DOCUMENT 2.3F

West Midlands Interchange			
Project THE WEST MIDLANDS RAIL FREIGHT INTERCHANGE ORDER 201X			
Drawing Status SUBMISSION			
Drawing Title ACCESS AND RIGHTS OF WAY PLAN SHEET 6 (INSET D AND E TO SHEET 1)		Drawing Size A1	
Regulation 5 (2) (k)	Document 2.3F		
Drawn NW	Date: JUNE 2018	Scale 1: 1000	Reviewed JF
Drawing No. WSP-70001979-SK-060			Rev. D

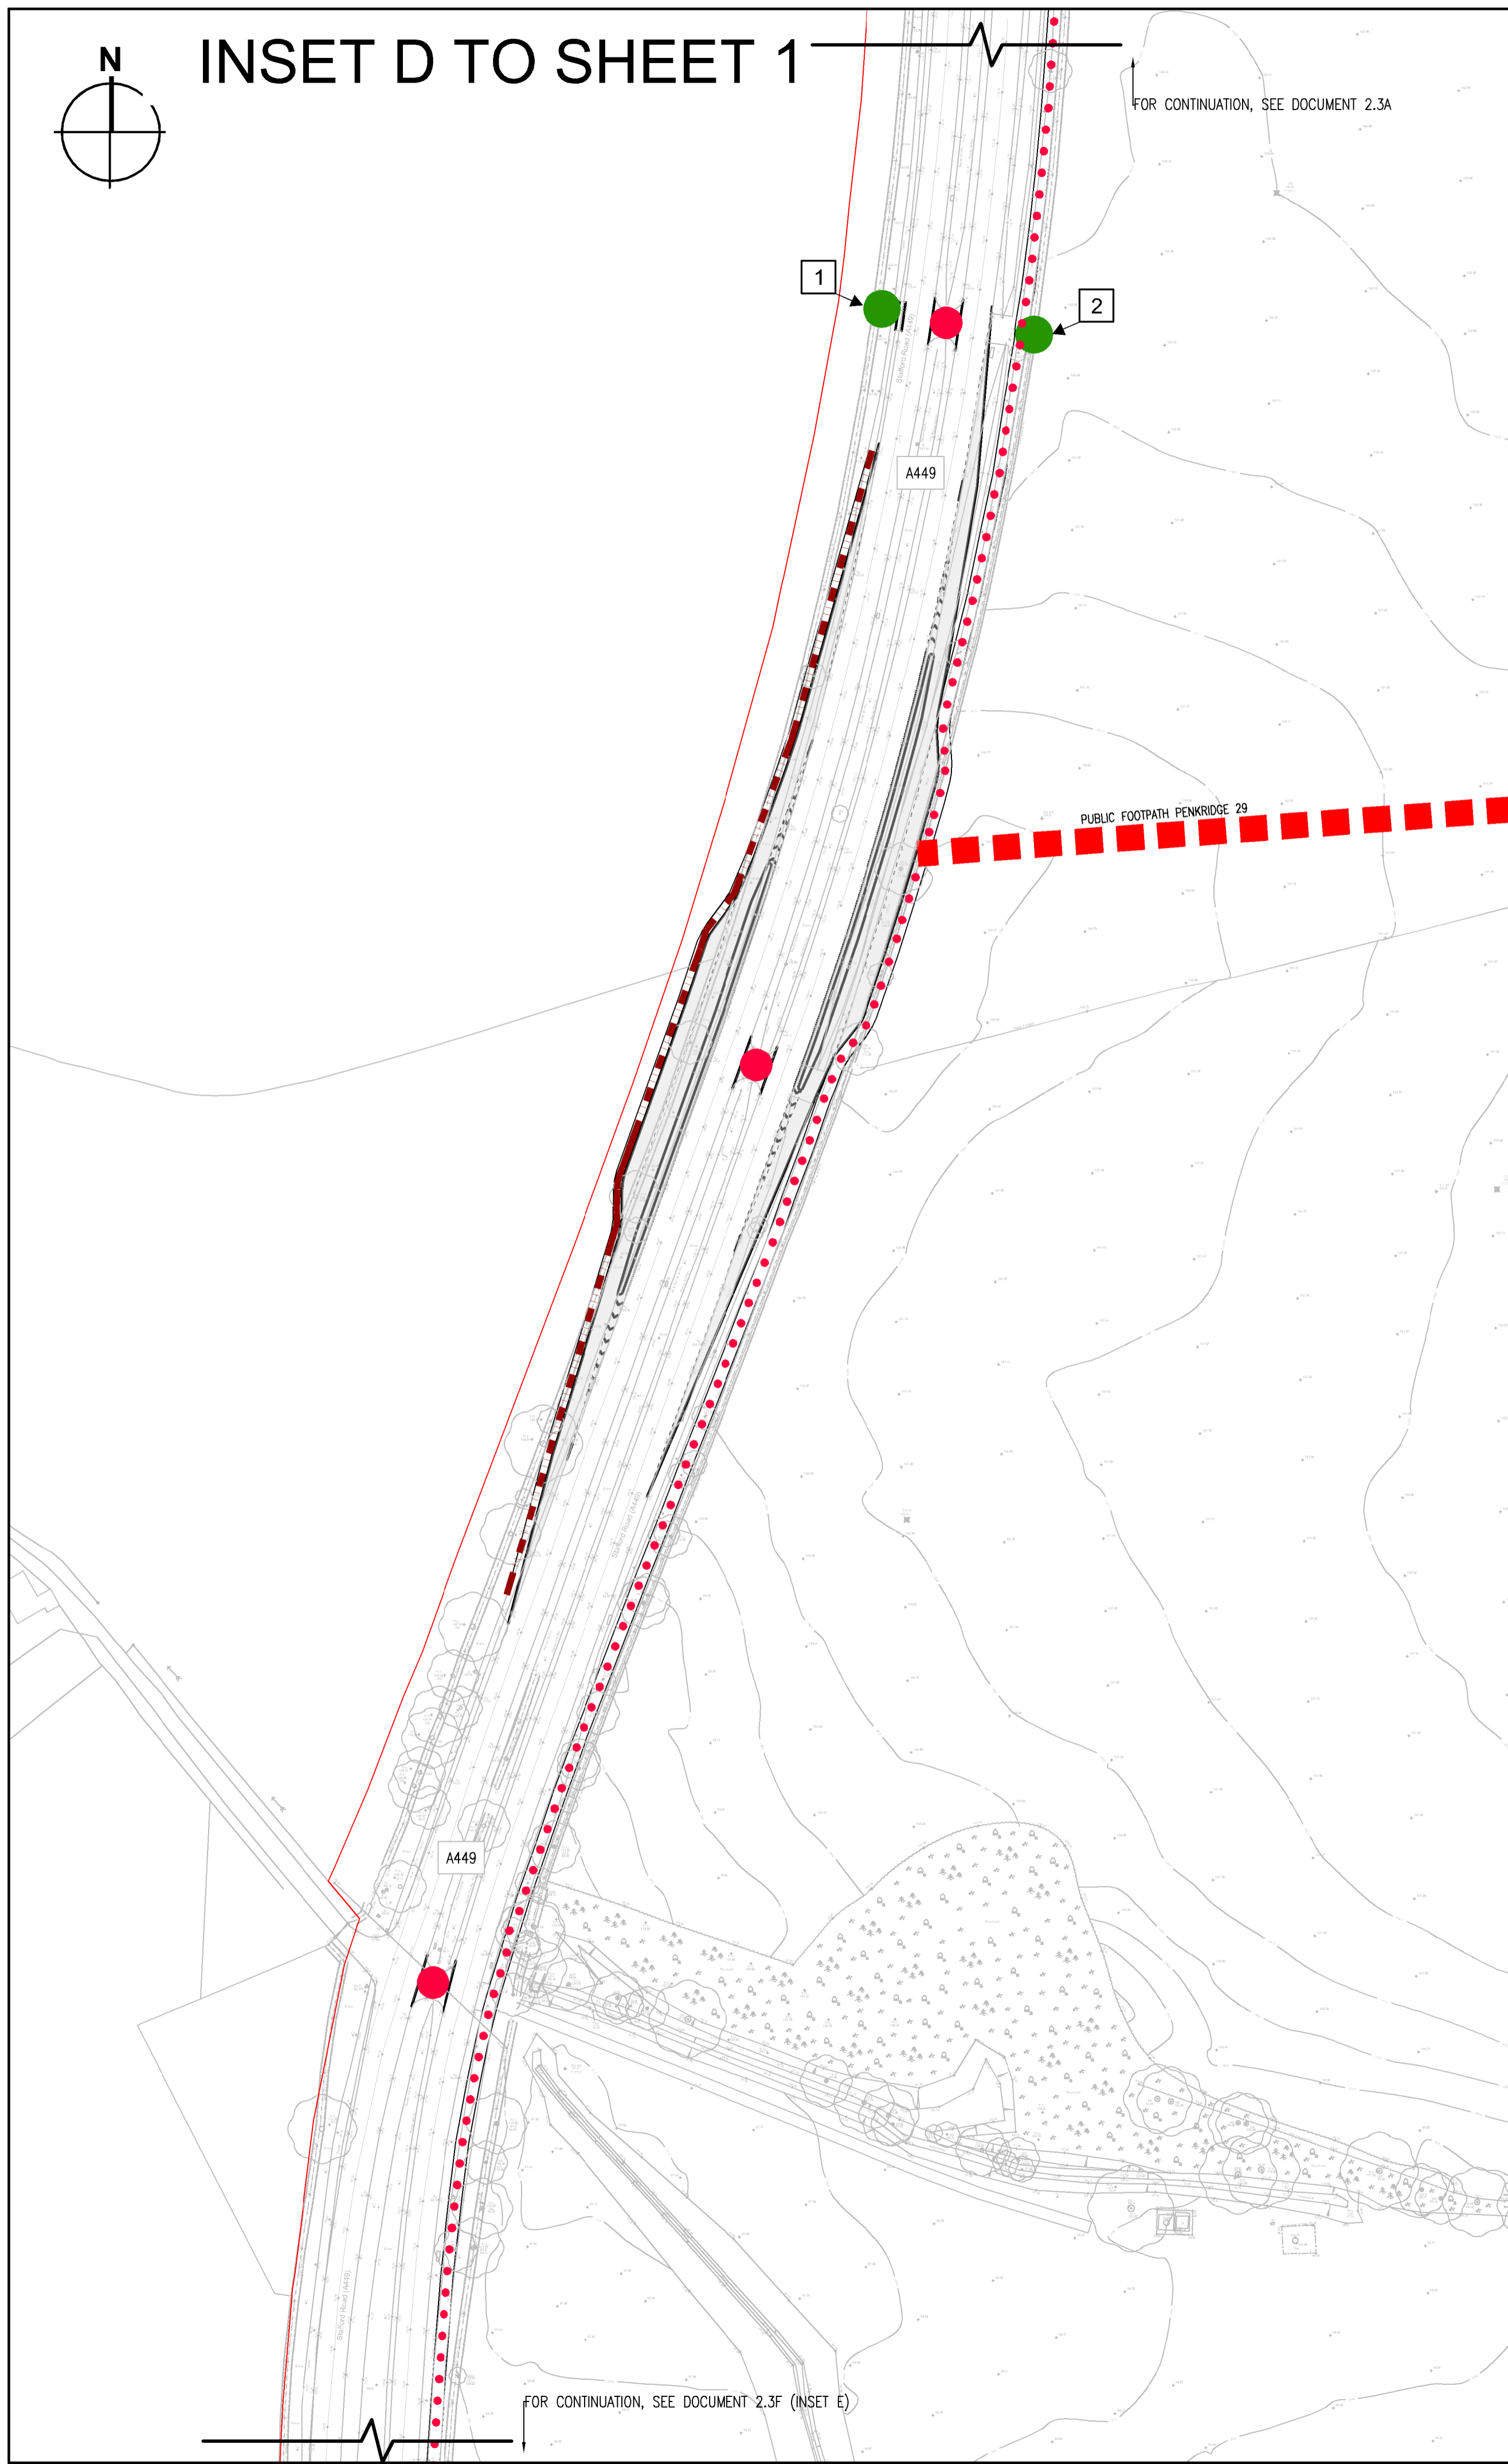
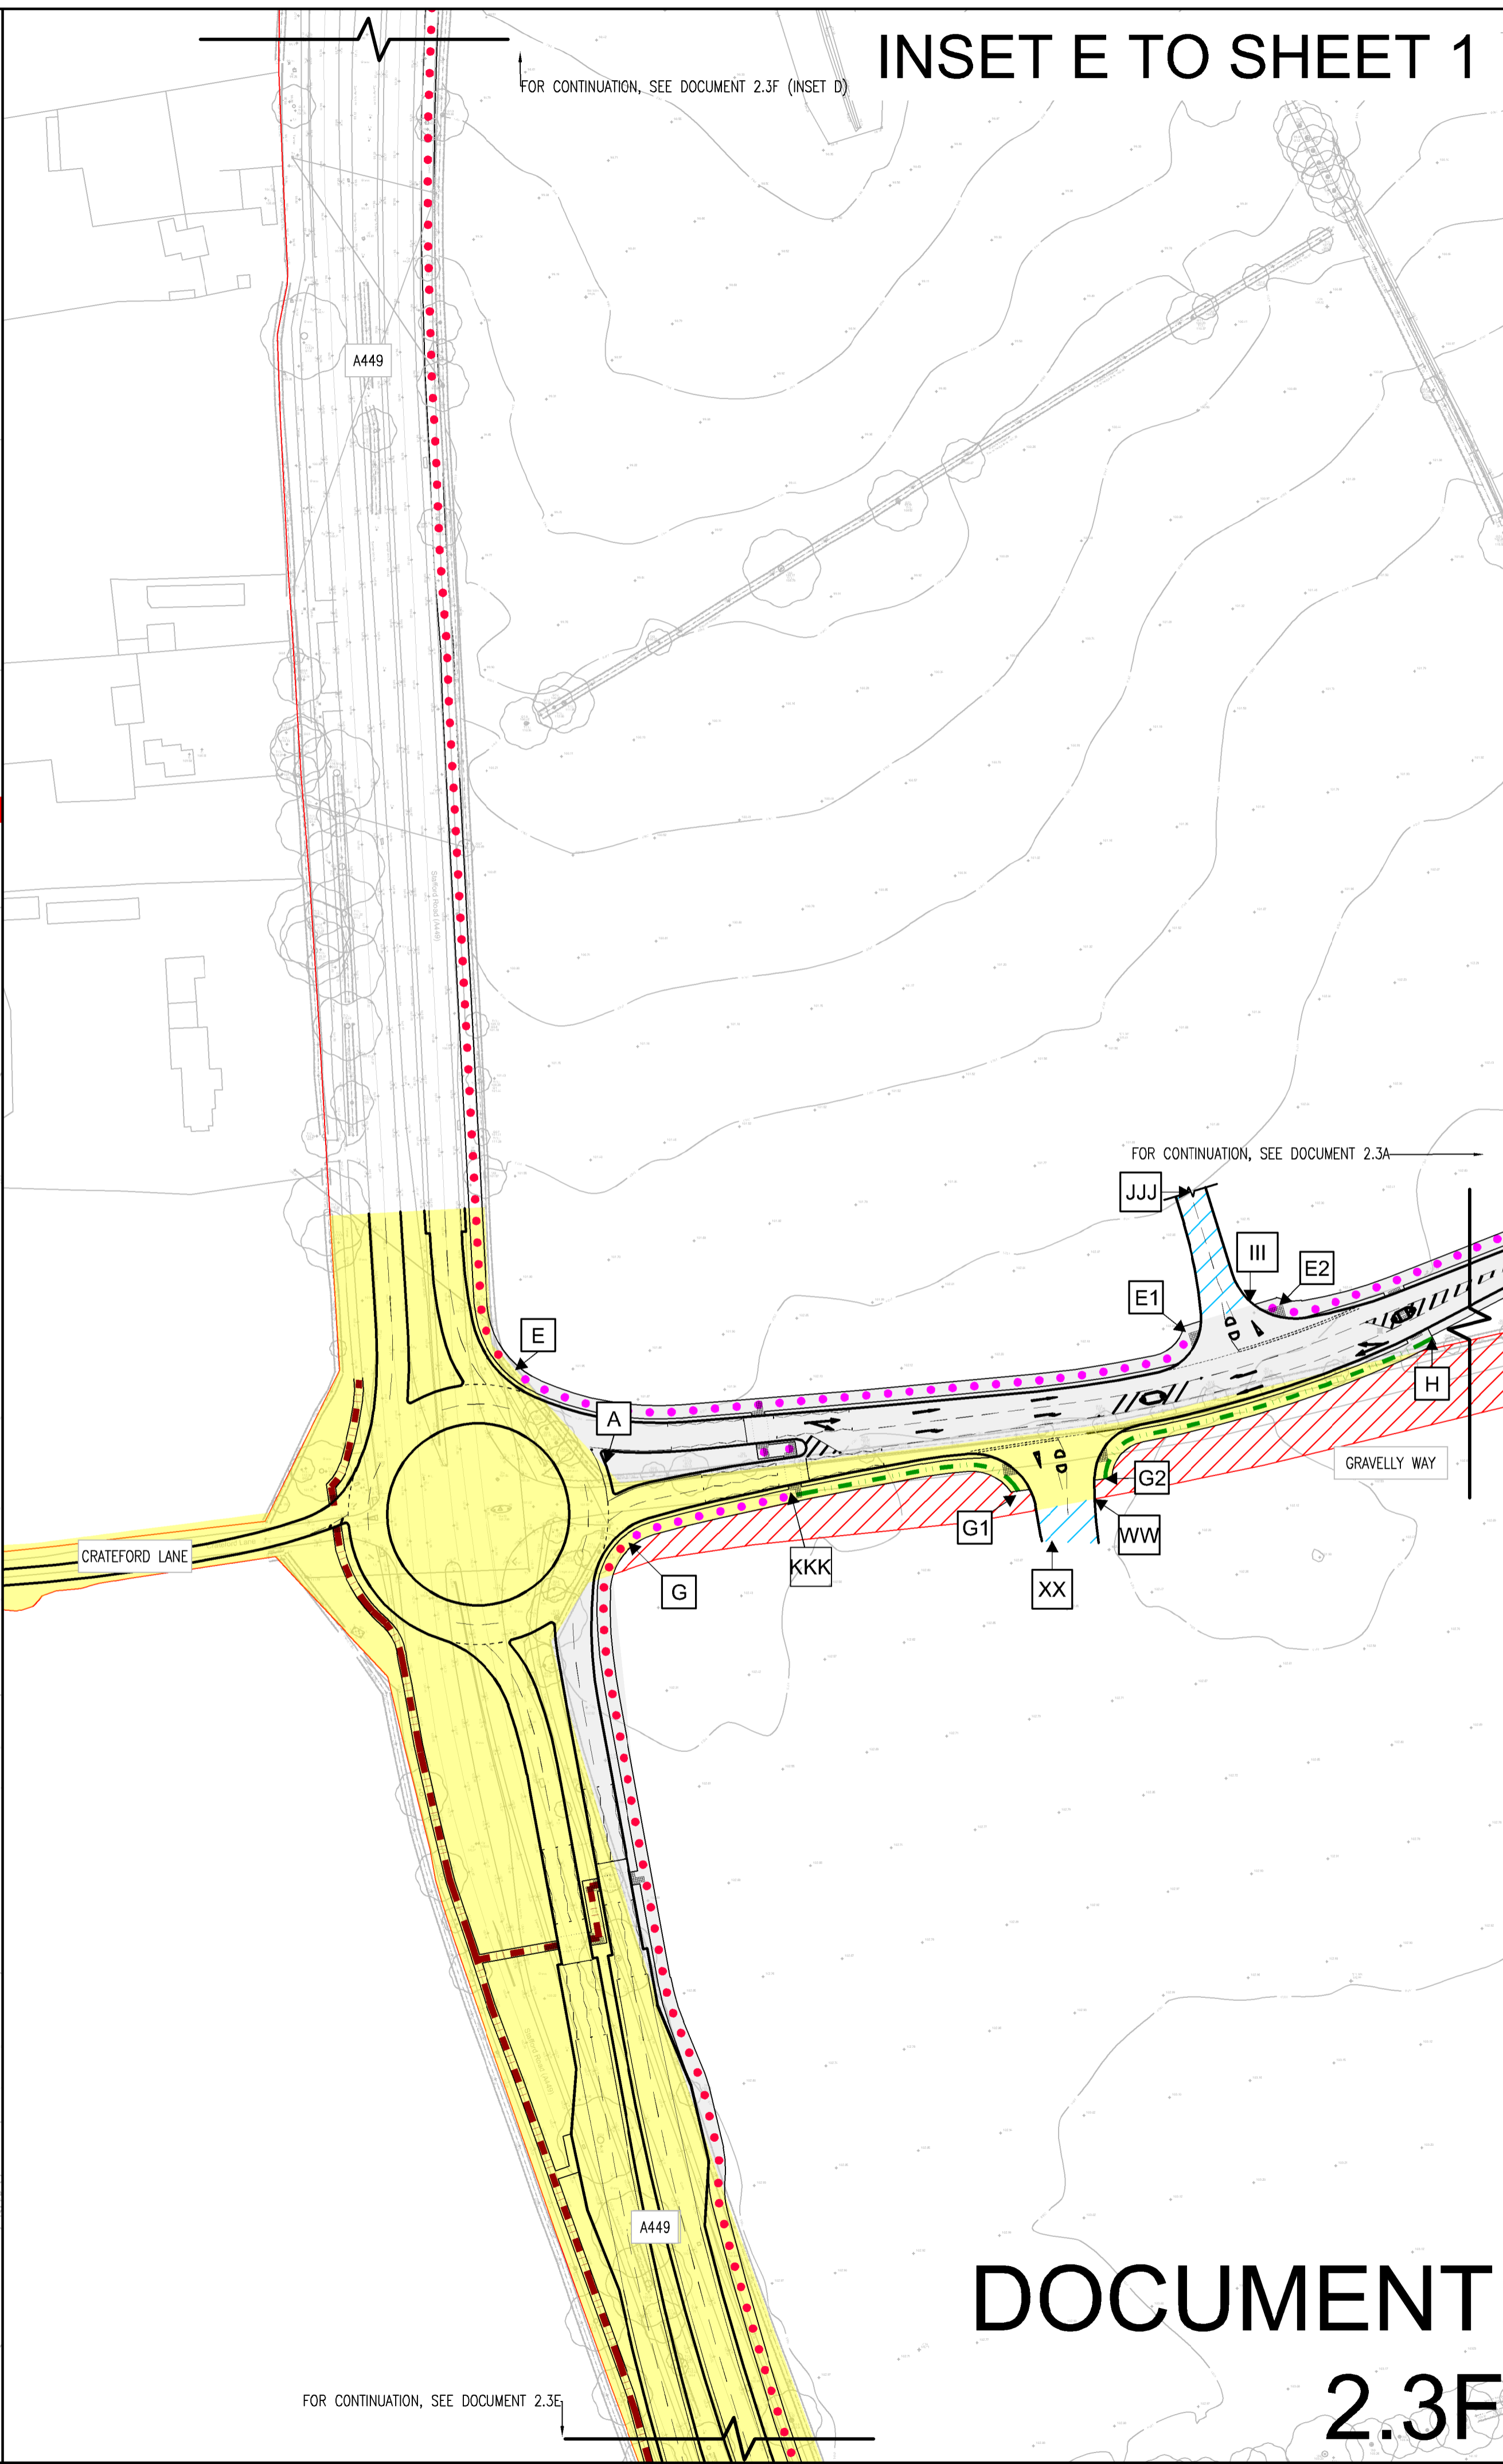
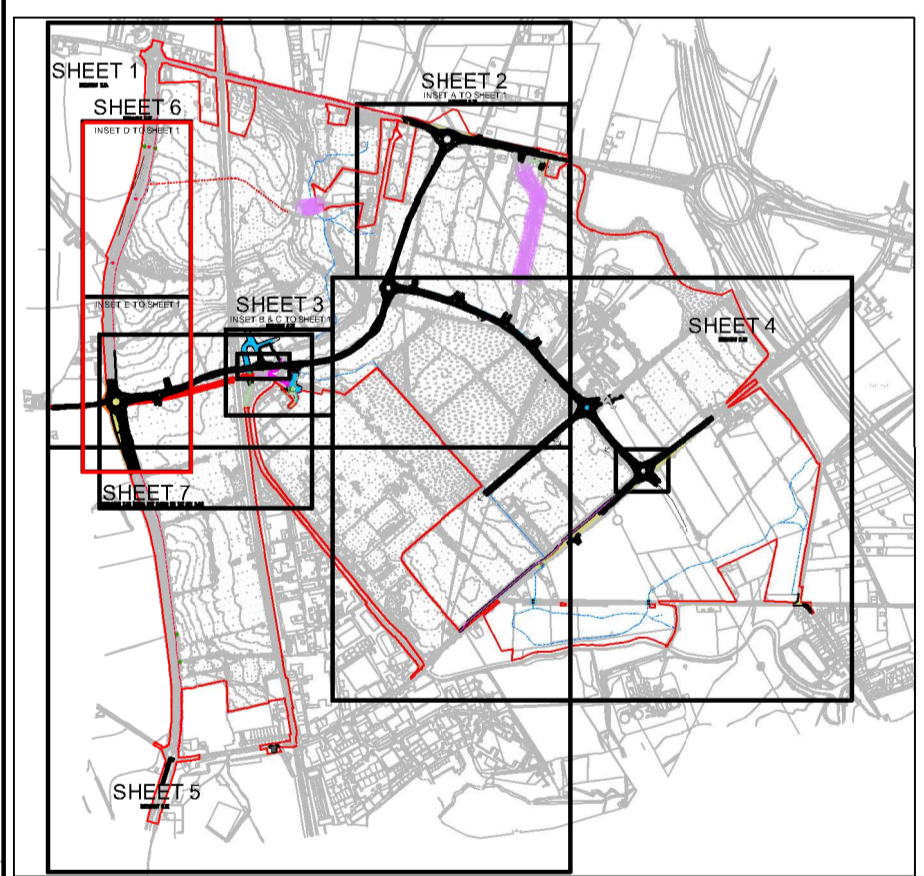
- CHANGES MADE TO DOCUMENT 2.3F SINCE DCO SUBMISSION:
- MAY 2019
- PEDESTRIAN CROSSING ON THE A449 SIGNALISED AND RELOCATED FURTHER SOUTH OF THE ROUNDABOUT IN RESPONSE TO COMMENTS FROM HIGHWAYS ENGLAND IN RSA.
 - PEDESTRIAN CROSSING ON GRAVELLY WAY MOVED EAST, STAGGERED AND SIGNALISED IN RESPONSE TO COMMENTS FROM HIGHWAYS ENGLAND IN RSA AND AS A RESULT, THE ACCESS TO THE RAIL TERMINAL HAS BEEN MOVED EAST. THE TOTAL WIDTH OF THE GRAVELLY WAY ARM HAS BEEN INCREASED TO PROVIDE SUFFICIENT WIDTH FOR THE CROSSING AND VEHICLE MOVEMENTS.
 - FOOTWAY WEST OF THE A449 HAS BEEN RELOCATED AND RECLASSIFIED AS CYCLEWAY / FOOTWAY IN RESPONSE TO COMMENTS FROM HIGHWAYS ENGLAND IN RSA.
 - ADDITIONAL VERGE ON THE EASTERN SIDE OF THE A449 HAS BEEN ALLOCATED TO ENSURE VISIBILITY TO THE PEDESTRIAN CROSSINGS IS PROTECTED.
